# SERVICE NO.05 LETTER

Piper Aircraft Corporation

TO: MODEL AFFECTED: All Distributors, Dealers, Owners and Operators PA-24 Comanche, Serial Numbers Listed Below

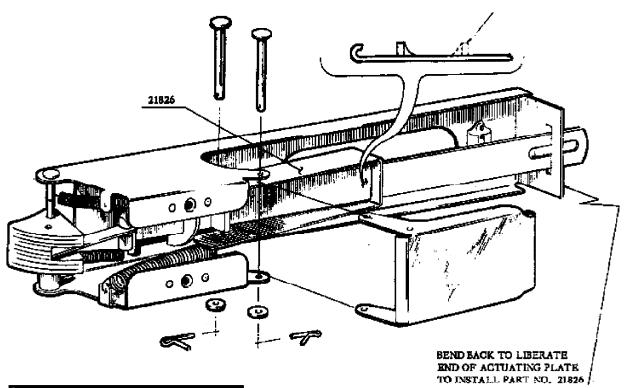
2. Rotate oil separator and install new hose part number 82371-17 and hose adapter part number 451 861 (AN840-9D) per Sketch "B" below this letter.

DOOR LATCH MODERICATION				
SKETCH "A"			S.L. #305	
PIPER AIRCRAFT CORPORATION				
	LC HAVEN, PENNSYLVANIA

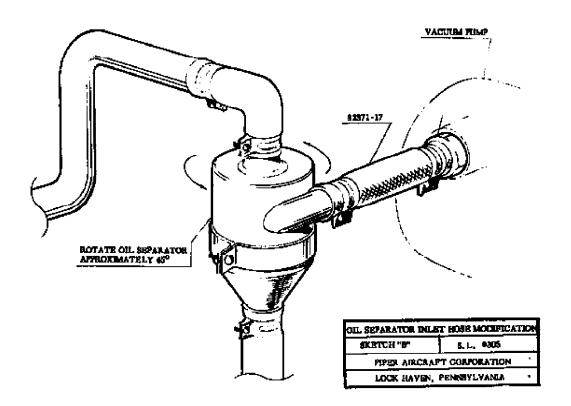
1. The main cabin door latch has been modified to provide a positive means of opening the door from the inside when it has been locked from the outside. We suggest that your door be revised as follows. Remove door latch assembly by loosening door trim upholstery and removing screws attaching latch plate and latch assembly to door frame. Disconnect latch pull rod from inside door handle and remove complete latch assembly. Modify latch assembly per Sketch "A" below this letter and install a new part number 21826.

L. G. Retraction Tube Arms Modification				
SKETCH "C"	S. L. #305			
PIPER AIRCRAPT CORPORATION				
LOCK HAVEN, PENNSYLVANIA

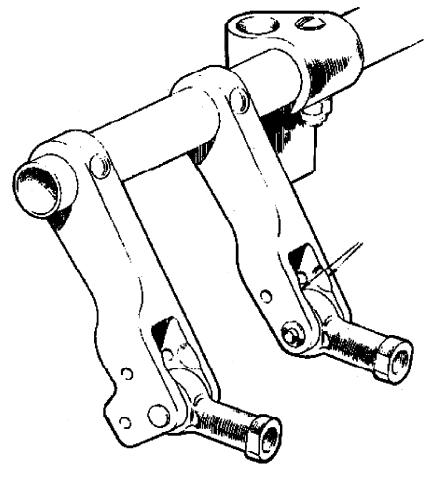
4. To prevent interference between the landing gear retraction tube arms and the retraction tube rod end bearings, the arms shall be modified per below this letter.
